ADDENDUM 4

September 11, 2018

Contract 15-C-00044; Louisiana Pump Station Rehabilitation

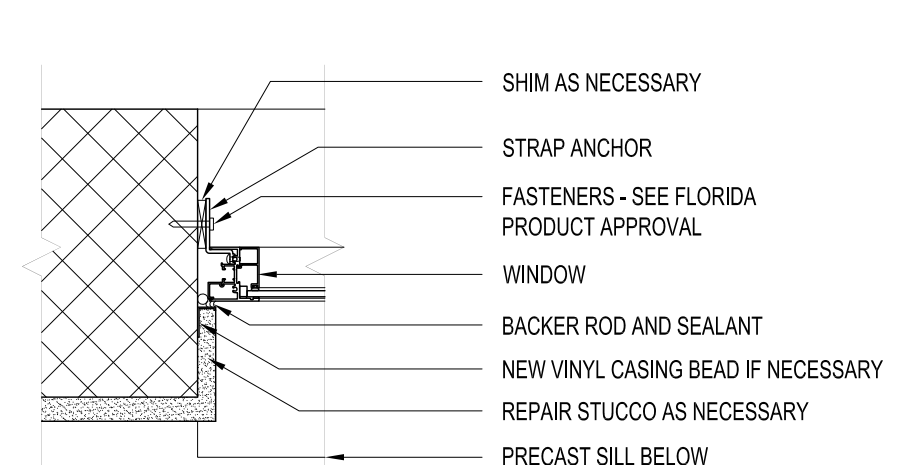
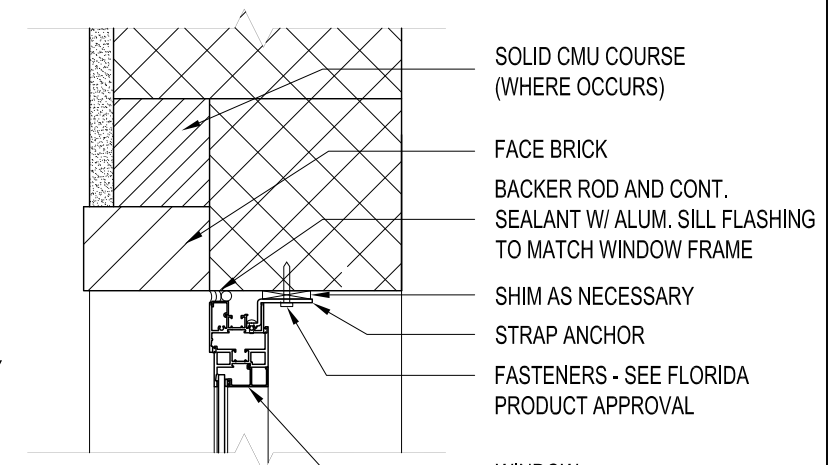
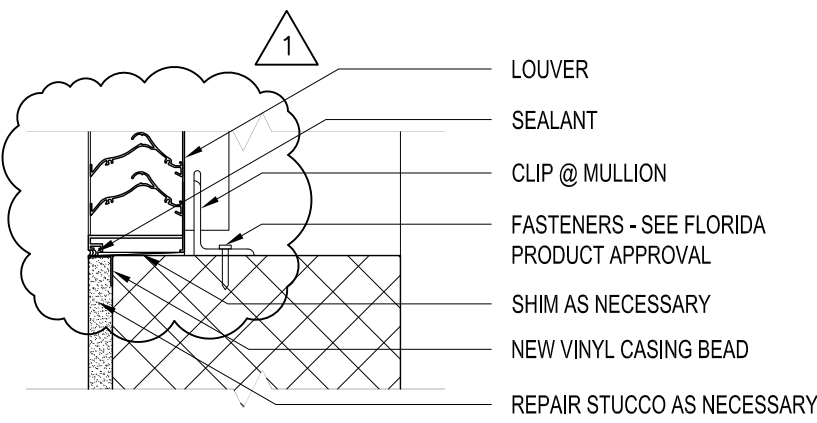
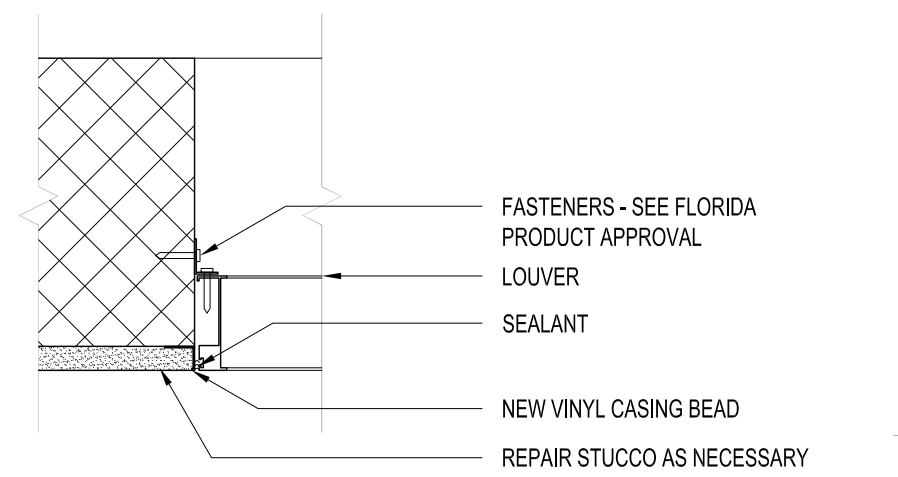
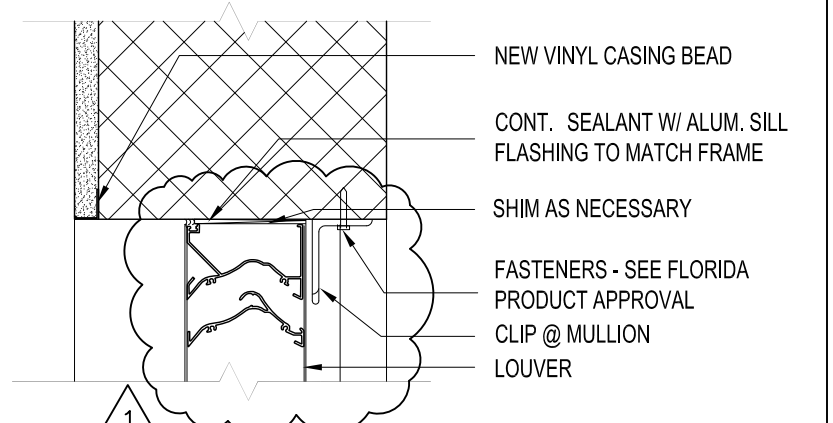
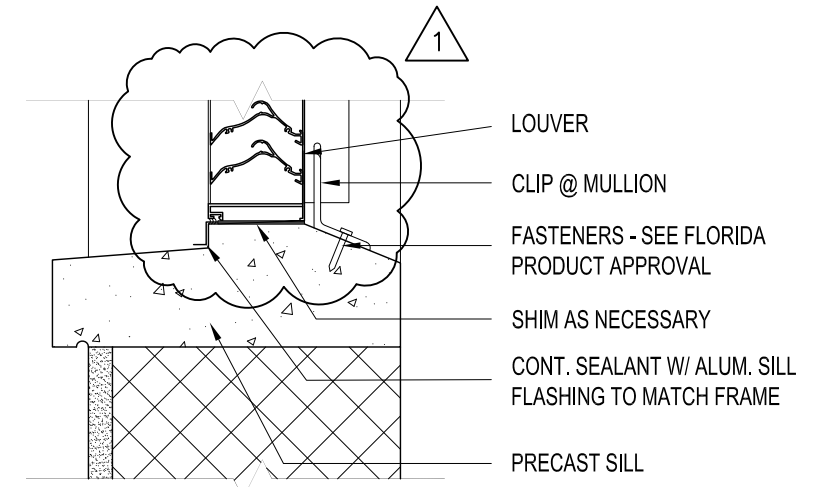
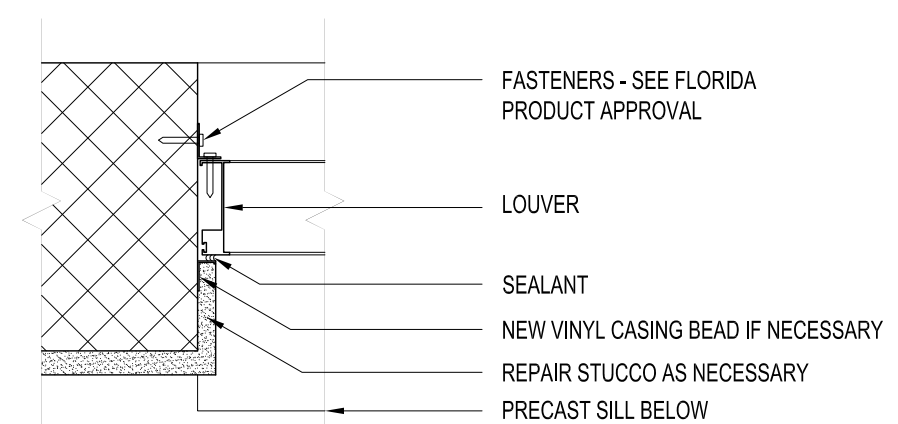
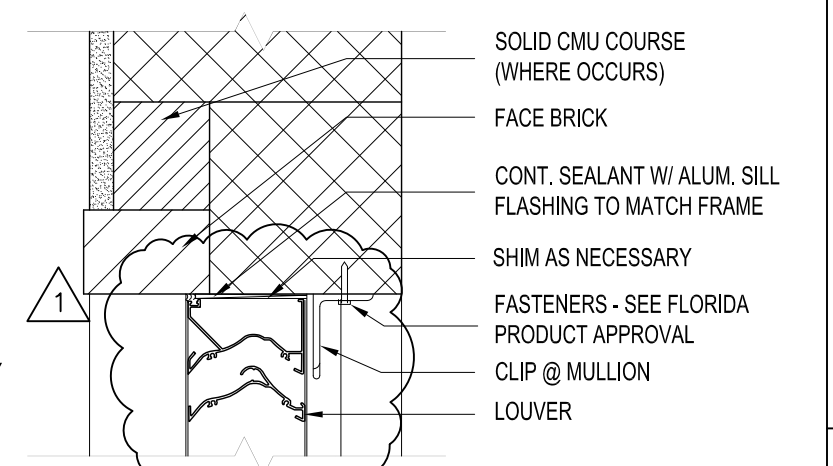
Item 4: Replace Architectural Sheets A-17 and A-18 with the attached revised sheets.
